D2.2 Comment

Annex 162 (CA), 162A/B/C/D

Clause	Topic	Comments
162	CA RLcc	89(R)
162A	Host PCB ILdd	18, 19
162B	MTF ILdc/ILdc	138
162B	MTF RLcc	136
162C	MDI pins table	157
162D	CA types	140
1/162/162D	MDI labels/references	156, 158, 151, 153, 152, 154, 155, 161, 162

162B.1.3.3 Mated test fixtures common-mode to differential-mode insertion loss

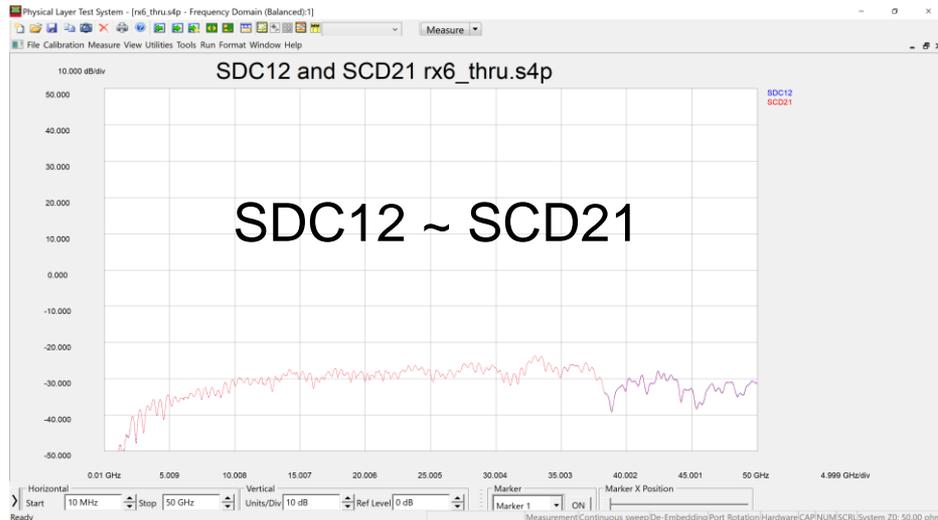
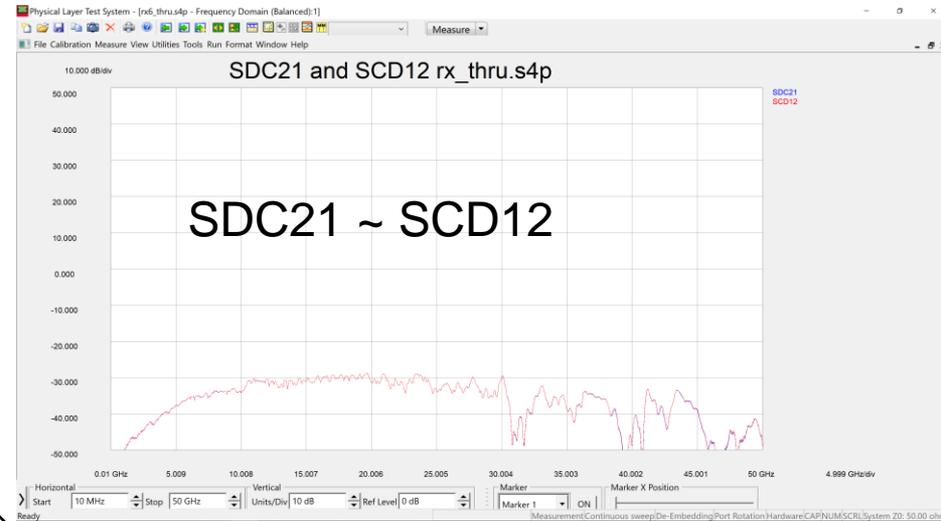
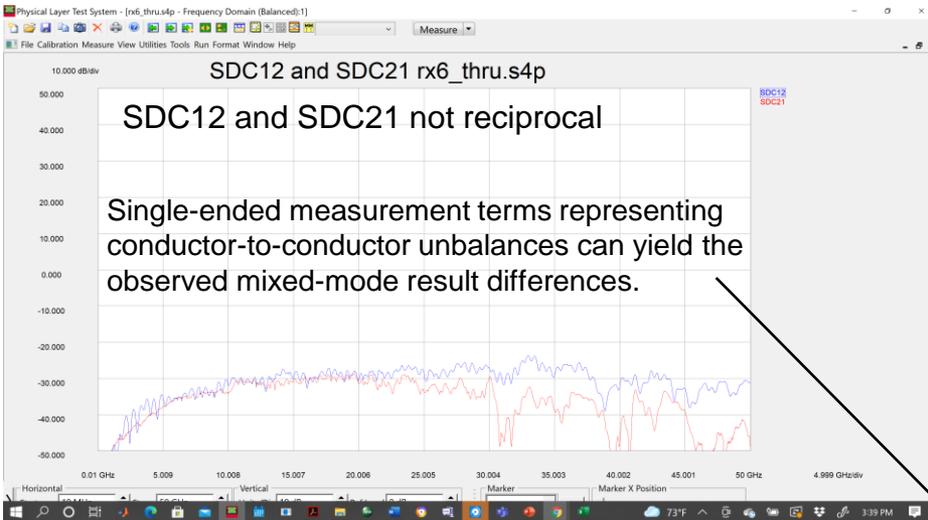
Cl 162B SC 162B.1.3.3 P 297 L 36 # 138
 Dawe, Piers Nvidia
 Comment Type T Comment Status D MTF ILdc/ILdc

If common-mode to differential-mode insertion loss is what we want to control, that's ILdc. However, we want to control both ILdc and llcd, as we have both RLcd and RLdc specs in 120G. There is an argument that they are the related, and specifying one is enough, but I'm not sure it always holds.

Error ILcd should be ILdc

- As these are test fixture specifications, SDC12, SDC21,SCD12, and SCD21 should be specified

Need a minimum of two measurements SDC12 and SDC21
 SCD12 and SCD21
 SDC12 and SCD12
 SDC21 and SCD21

Specify both llcd and ILdc. It may be possible to specify one in one direction and the other in the other: Scd21 and Sdc12, or Sdc21 and Scd12, where 1 is an input (instrument connector that would be connected to a pattern generator) and 2 is an output. I haven't thought through which we need, or maybe we need all four. It is simpler to require all four.

PROPOSED ACCEPT IN PRINCIPLE.
 This comment does not apply to the substantive changes between IEEE P802.3ck D2.2 and D2.1 or the unsatisfied negative comments from previous drafts. Hence it is not within the scope of the recirculation ballot.
 However, the proposed change is an improvement to the draft.
 As pointed out by the comment both llcd and llcd of the MTF must be similarly constrained. Since ILcd12 and ILdc21 are reciprocal and ILcd21 and ILdc12 reciprocal, the insertion loss mode conversion can be constrained by measuring either llcd (or llcd) in both directions. The text as written was intended to require this but the wording could be improved.
 Also, the variable "llcd" should be "llcd" to correctly reflect the subclause title and text.
 Change: "measured at either test fixture test interface"
 To "measured in both directions"
 and
 Change variable name "llcd" to "llcd".

162B.13.3 Mated test fixtures common-mode to differential-mode insertion loss

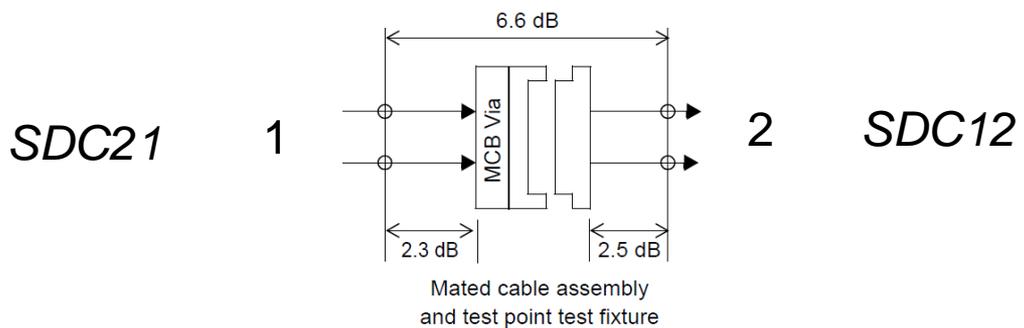
- Minimal changes to the draft
 - Correcting IL_{cd} to align with subclause description
 - Change "the mated test fixture measured at either test interface" to "the mated test fixture measured in both directions"

Need a minimum of two measurements
SDC12 and SDC21

162B.1.3.4 Mated test fixtures common-mode to common-mode return loss

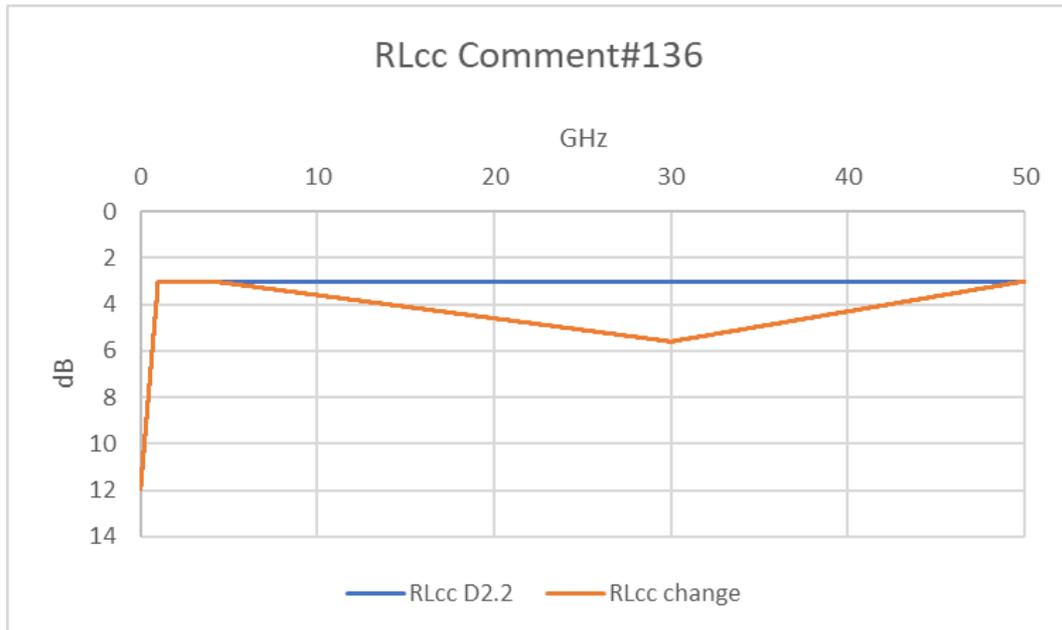
CI 162B SC 162B.1.3.4 P 298 L 30 # 136

Just as for the cable RLcc spec: this 3 dB becomes useless when the MCB trace loss is half of 3 = 1.5 dB (16 GHz).

As for the cable RLcc spec but 1 dB lower to 30 GHz, easing up to 50 GHz: 12 -9f dB 0.01 <= f <1, 3 dB 0.5<= f <= 4 GHz, 2.6+0.1*f dB 4 < f <= 30 GHz, 9.5-1.3*f dB 30 < f <= 50 GHz. f is in GHz.

12 -9f 0.01 <= f <1
 3 1 <= f <4 GHz
 2.6+0.1f 4 <= f < 30 GHz
 9.5-0.13f 30 <= f <= 50 GHz

PROPOSED REJECT.
 The comment and suggested remedy does not provide sufficient information or justification to support a change to the draft.
